Chip Errata
DSP56156 Digital Signal Processor
 Mask: E25H

ERRATA

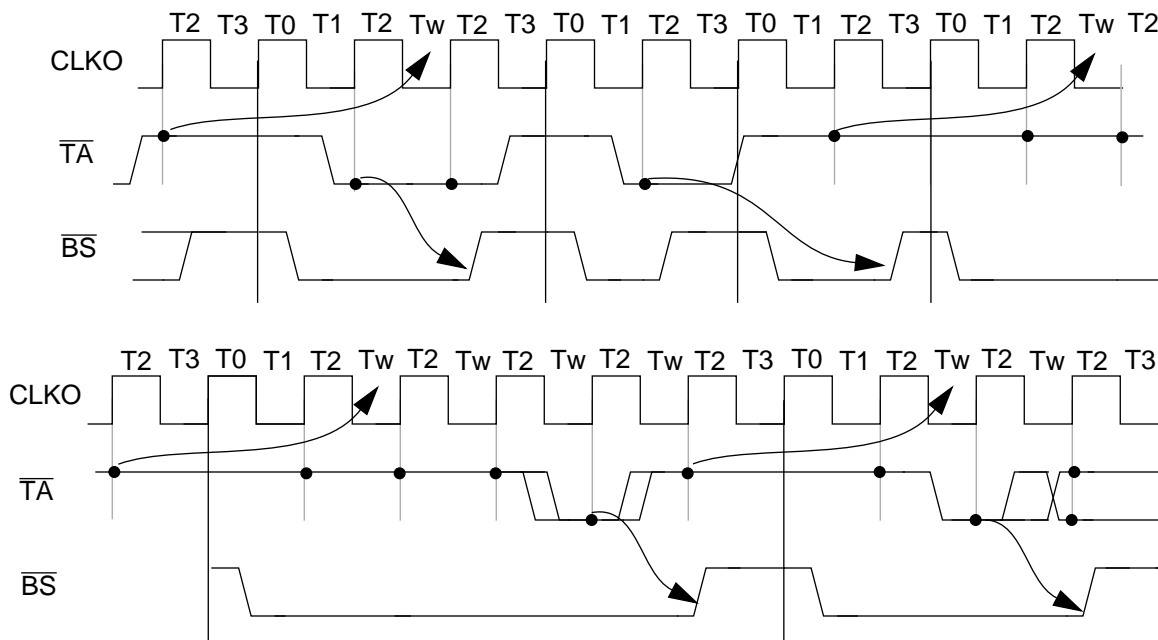
2. The \overline{TA} pin behavior of this mask set (as well as all previous mask sets) does not match the \overline{TA} definition described in the DSP56156 data sheet (2/1/92). The \overline{TA} behavior is described below; it will be changed to the behavior described in the data sheet in a later revision of the silicon:

\overline{TA} (Transfer Acknowledge) - active low input. If there is no external bus activity, the \overline{TA} input is ignored by the DSP. When there is external bus cycle activity, \overline{TA} can be used to insert wait states in the external bus cycle. \overline{TA} is sampled on the leading edge of T2. Any number of wait states from 1 to infinity may be inserted by using \overline{TA} . If \overline{TA} is sampled high one clock period before the beginning of a bus cycle, at least one wait states will be inserted in the bus cycle. The bus cycle will end 4T after the \overline{TA} has been sampled low on a leading edge of the clock, if the Bus Control Register (BCR) value does not program more wait states. The number of wait states is determined by the \overline{TA} input or by the BCR, whichever is longer. \overline{TA} is still sampled during the leading edge of the clock when wait states are controlled by the BCR value. In that case, \overline{TA} will have to be sampled low during the leading edge of the last wait state programmed by the BCR (4T before the end of the bus cycle programmed by the BCR) in order not to add any wait states. If \overline{TA} is sampled low (asserted) at the leading edge of T2 preceding the bus cycle, and if no wait states are specified in the BCR register, zero wait states will be inserted in the external bus cycle.
